Serial No.: 09/762,223

Title: **DEVICES AND METHODS FOR THE REPAIR OF ARTERIES**

**COMBINED PETITION UNDER 37 CFR §1.181(a)(1)
TO WITHDRAW PREMATURE FINAL REJECTION /
TO WITHDRAW HOLDING OF ABANDONMENT
(37 CFR §1.113(a); MPEP 706.07(c))**

Figure 10

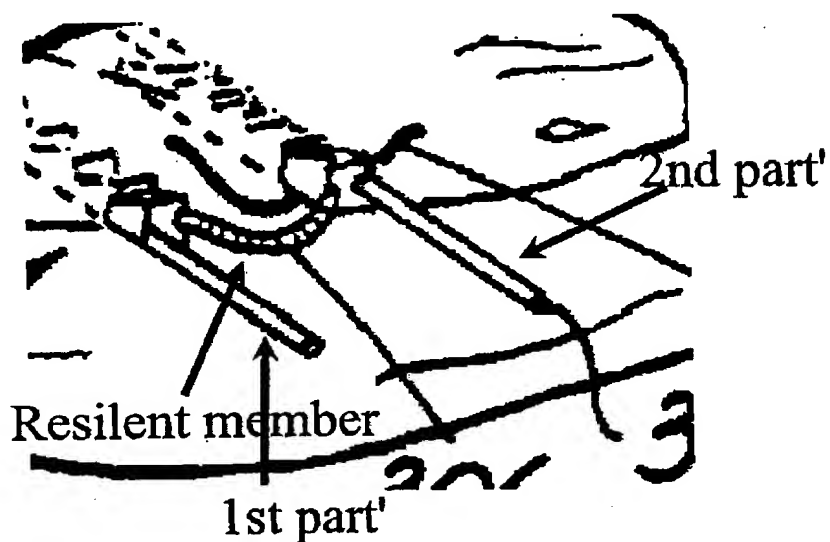
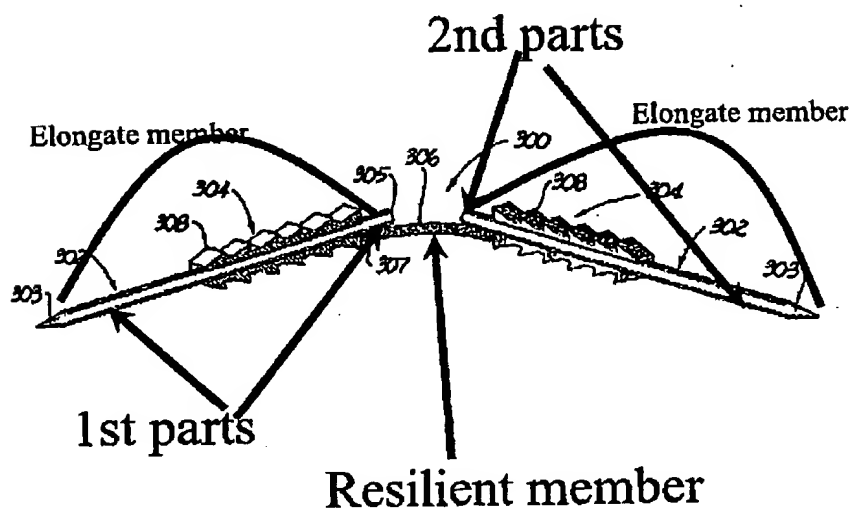
17. Regarding claim 68, the elongate member of the Green device has the capability of being in an open configuration, figure 14, and a retaining configuration, figure 1, where in the 1st and 2nd parts are closely spaced, wherein the device is biased towards the closed configuration. Further, the elongate member extends between the first and second element and is connected between the first and second ends. The modified Green device could be inserted into a graft-bearing artery to pierce the graft and artery. Once the device, part 1, is completely pushed through the artery, the graft and artery would be maintained between the first and second part where in the device would be in the closed position.

18. Regarding claim 69, the fixator has 2 parts that are sharpened, allowing it to pierce an artery and a graft (see figure 14).

Reconsideration of the rejections is requested.¹ Initially, note that claim 68 recites elongated members (in the plural). If *Green* is regarded as having a pair of elongated members 302/303/308/304 (as shown in the Examiner's second drawing in the Office Action), *Green* neither discloses nor suggests bending each of the elongated members as recited in claim 68; rather, each elongated member stays straight, with the bioresorbable connection between them (see column 8 line 62 onward) being bent. Note that the Fig. 10 apparatus is shown "spread" merely because the bioresorbable connecting material is not rigid, and that the apparatus is not in fact bent when deployed: as depicted in Figs. 7-9 and described in the specification, the *Green* apparatus is driven forward in a U-shaped form, see Figs. 13 and 14, with each "arm" being in parallel and being driven by needle 302, see Figs. 13 and 15, and the apparatus remains in this configuration when deployed, without the spacing between the arms being varied. After deployment, the bioresorbable connection between the arms dissolves while the arms remain in tissue as retaining spikes (see, e.g., column 10 lines 55-60). Thus, *Green* has no teaching or suggestion that a fixator may include an elongated member (much less multiple elongated members) wherein each elongated member is bent from a linear form to a form wherein its ends are closely spaced, such that each elongated member retains a graft and artery together. *Green* is simply a rather conventional surgical staple having linear arms which remain in linear form when installed in tissue, but the "bridge" of the staple is made of dissolving (and flexible) material. Consider that this flexible material cannot maintain the arms in a closely spaced condition (and in fact it cannot hold the arms in any fixed location owing to its flexibility), and thus there is no way to use the *Green* apparatus to fix an artery and graft in the manner claimed, nor is there any apparent reason why one would be motivated to modify the *Green* apparatus to provide this capability. In

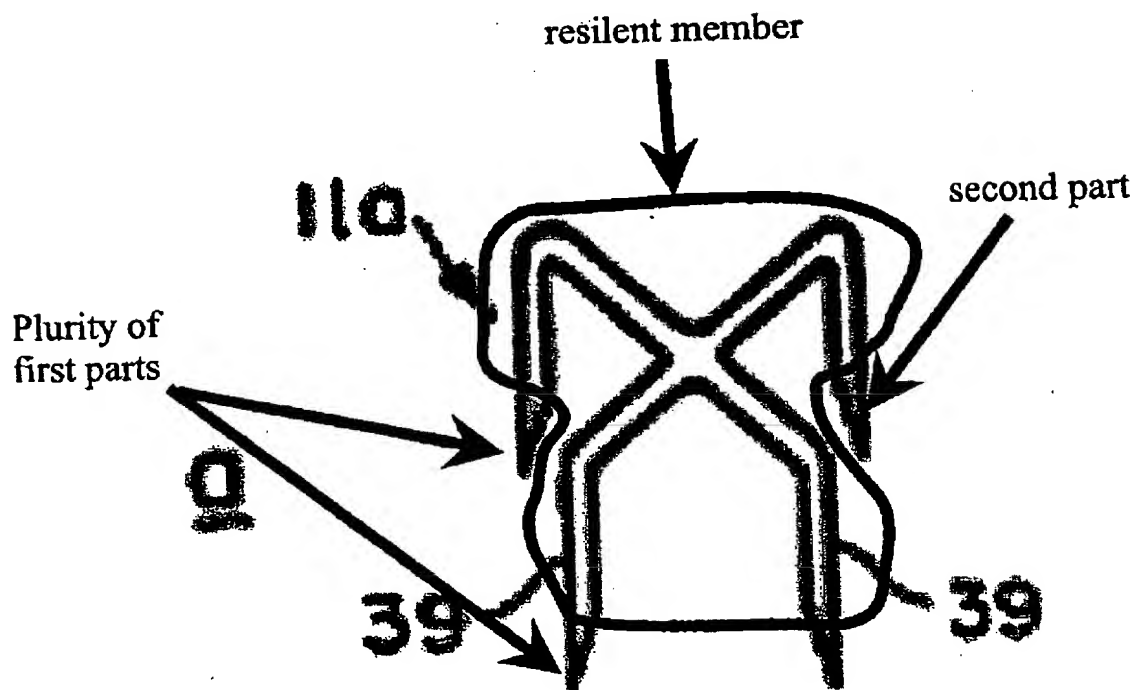
15. Regarding claim 63, the Krumme fixator can hold a graft.
16. Regarding claim 64, the Krumme device illustrated in figure 5a contains two elongated members (one elongated member has been painted gray in the attached diagram, the other one is white.) The elongated members have an open and closed configuration. In the open configuration, the first and second members are spaced; in the closed configuration, the first and second members are closer together.
